RFI

RFI #: 28
Date: 12/17/2019
Job: 18-075 LDS Wolftrap
Phone:

Subject: Shed/Dumpster Enclosure Dimensions

**CROWELL ROAD
MEETING HOUSE
OAKTON VA STAKE**
CROWELL RD AND HUNTER MILL RD
FAIRFAX, VIRGINIA 20190

Mark	Date (m-d-y)	Description
1	30-JAN-20	SHED & YARD UPDATES

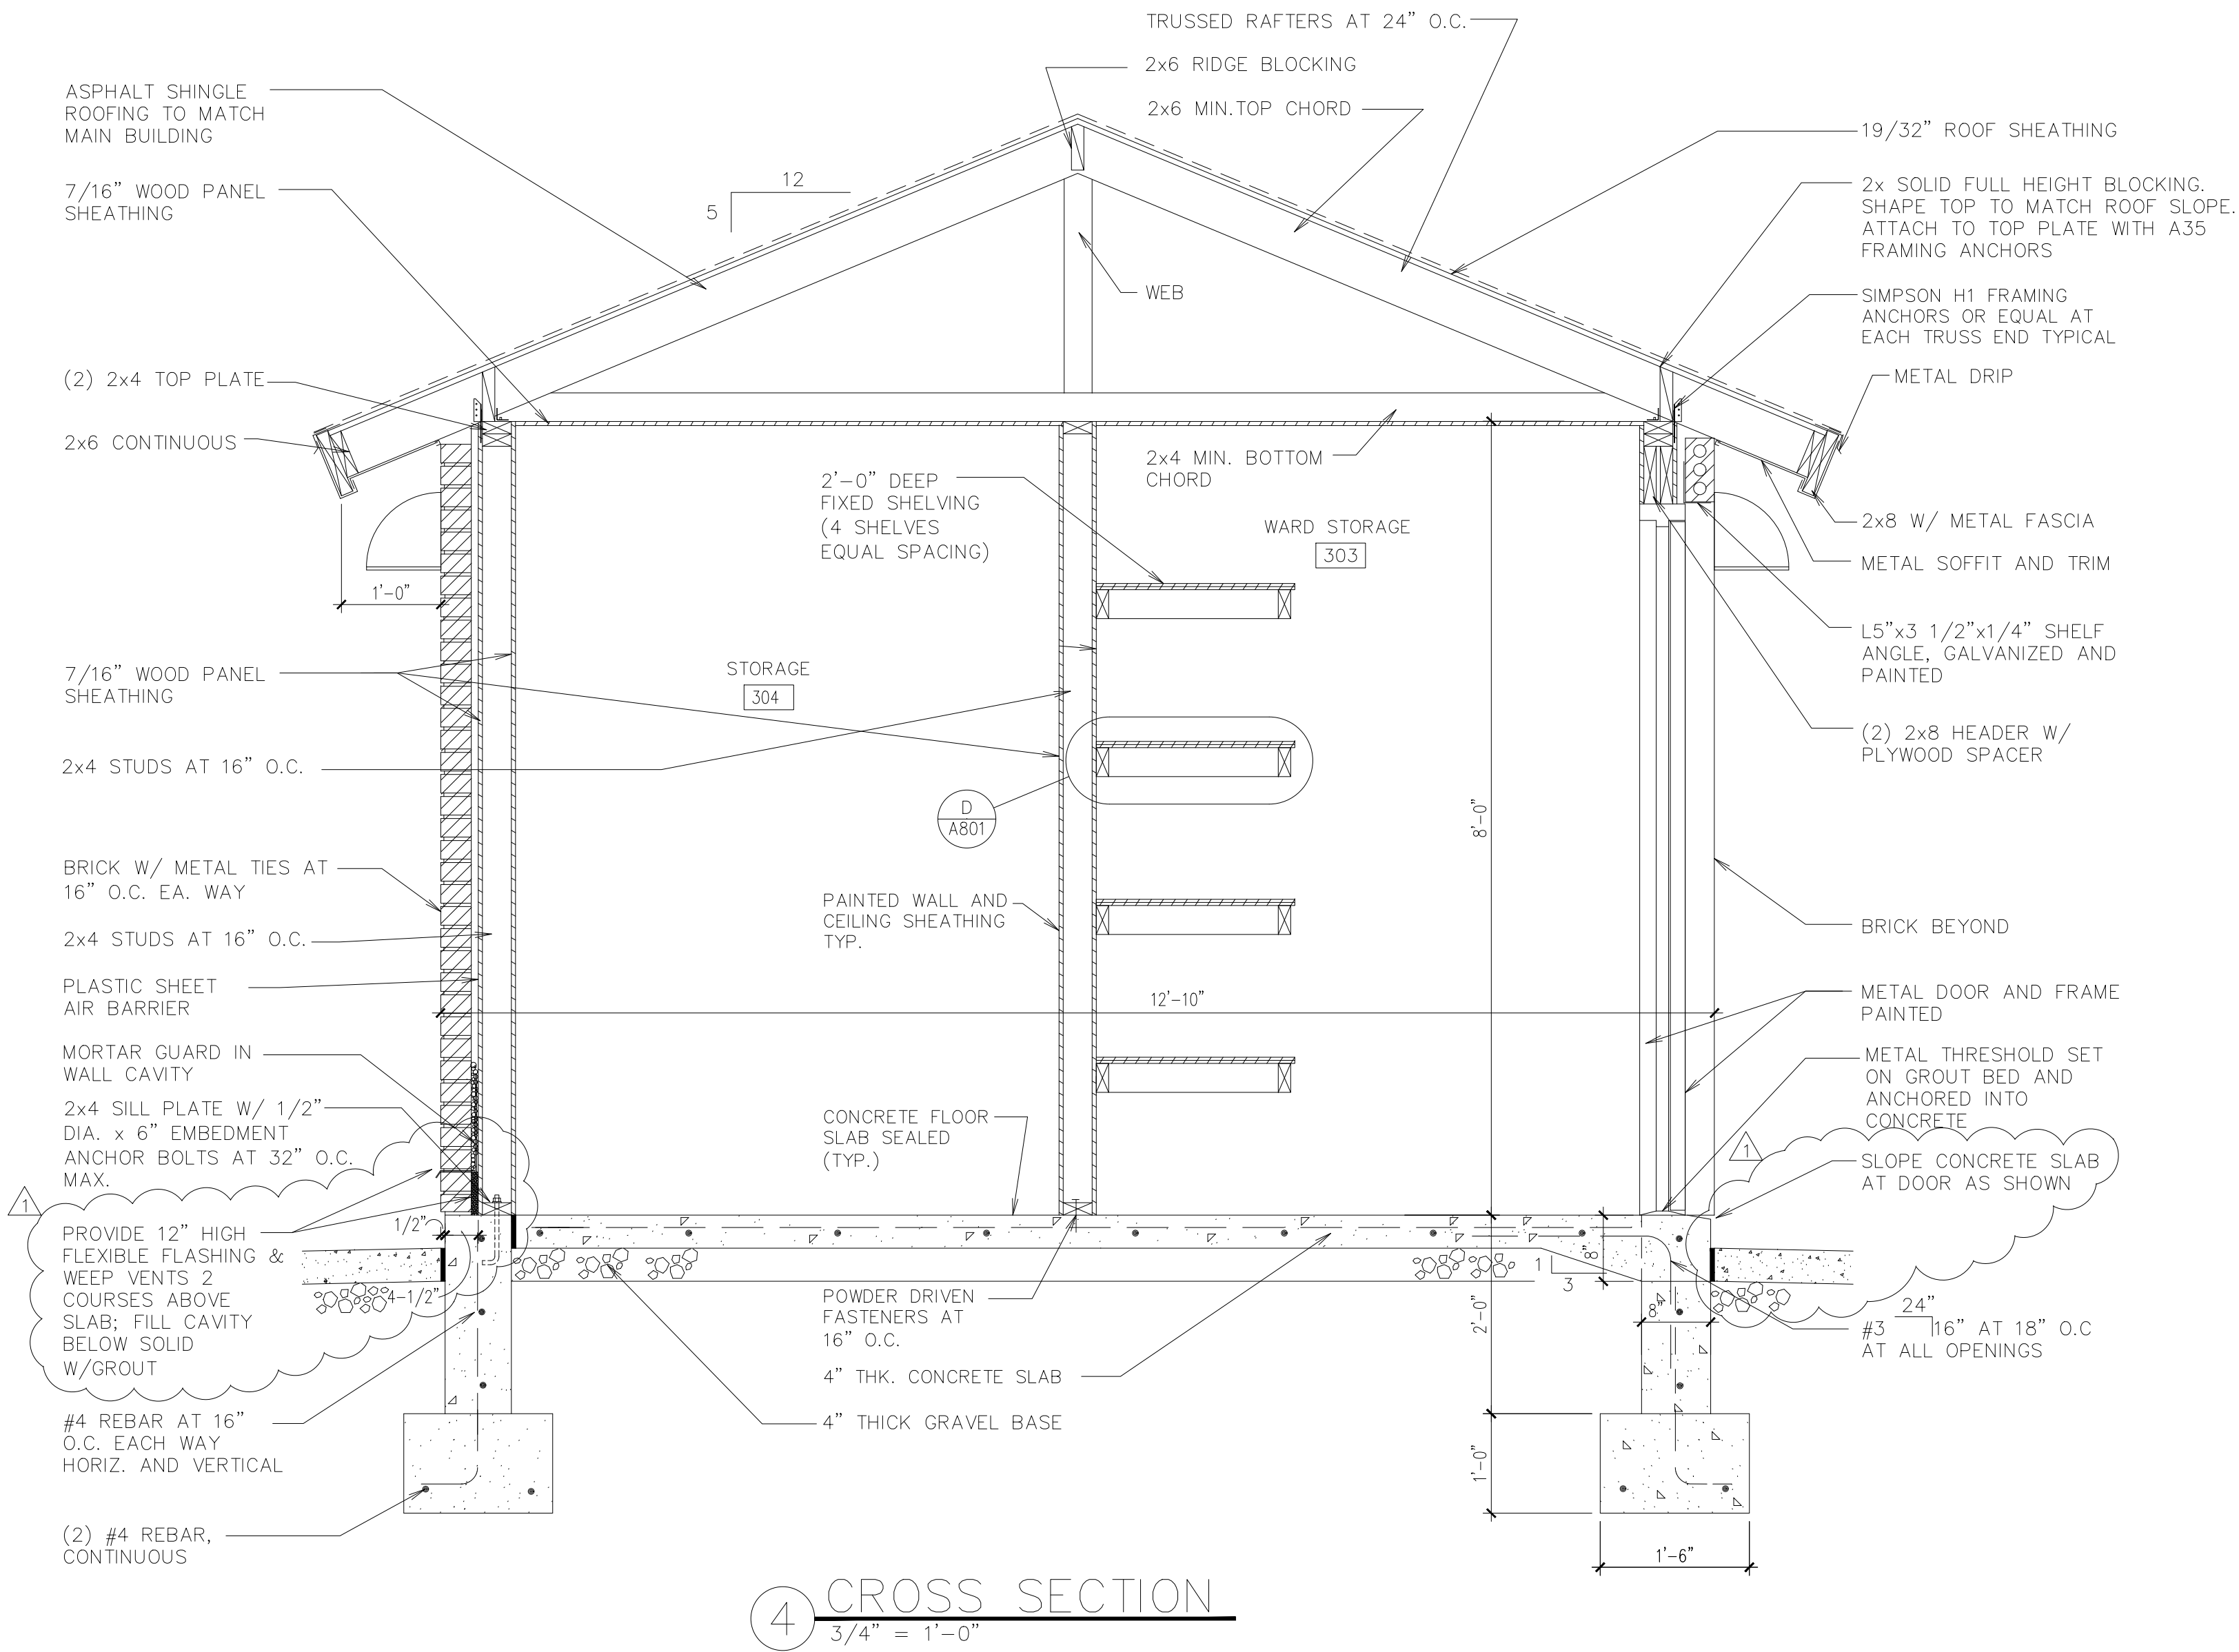
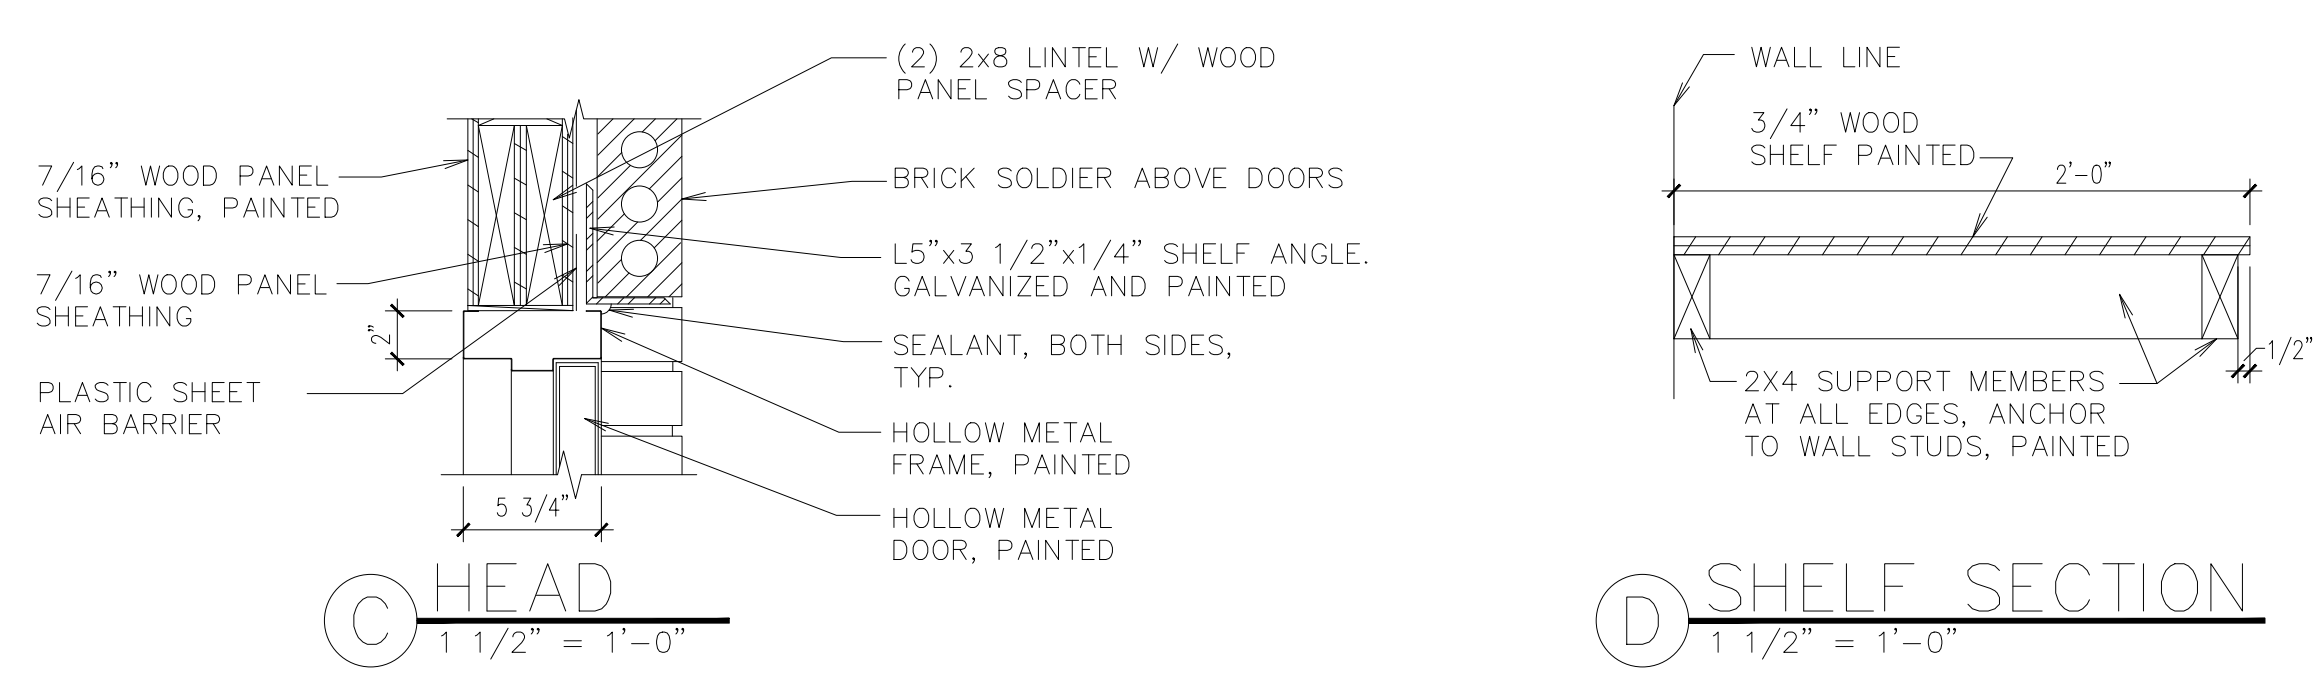
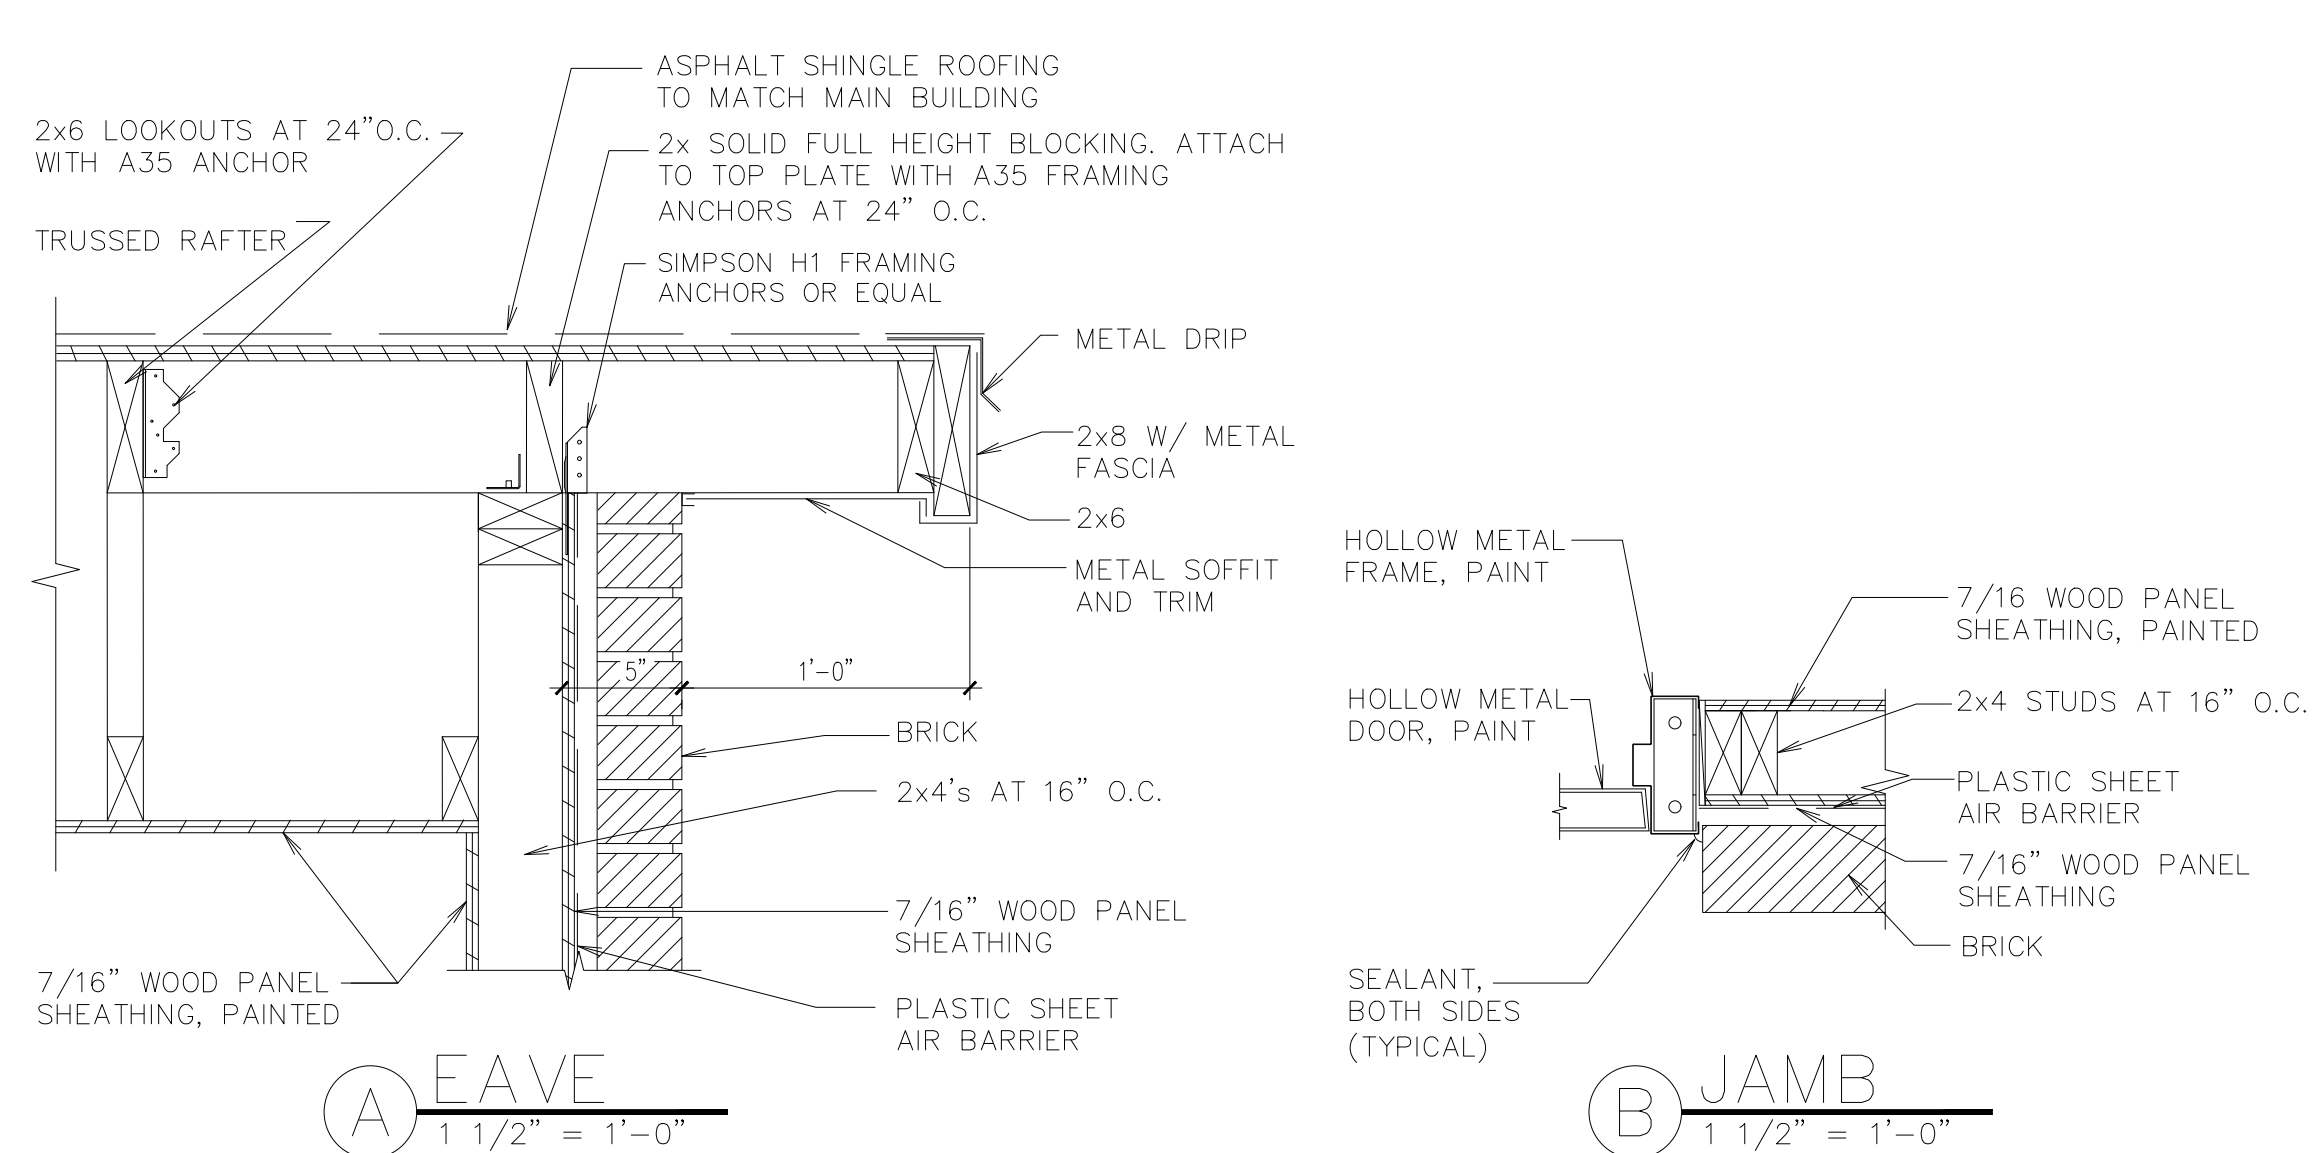
The concrete contractor has noticed a bust in the dimensions that Urban had set in the field. Sheet A801 calls out for the outside of shed concrete foundation to be 12'-9" X 14'-9" and sheet A802 shows the outside brick dimension as 12'. If the dimensions on sheet A801 are to be used the dimensions on sheet A802 will need modified. Can you provide us with the correct dimensions?

Please see attached Sheets A801 and A802, issued with today's date with corrected notes and dimensions. 1/A801, 4/A801 & 1/A802 have been updated in whole or in part, as indicated by the clouds.
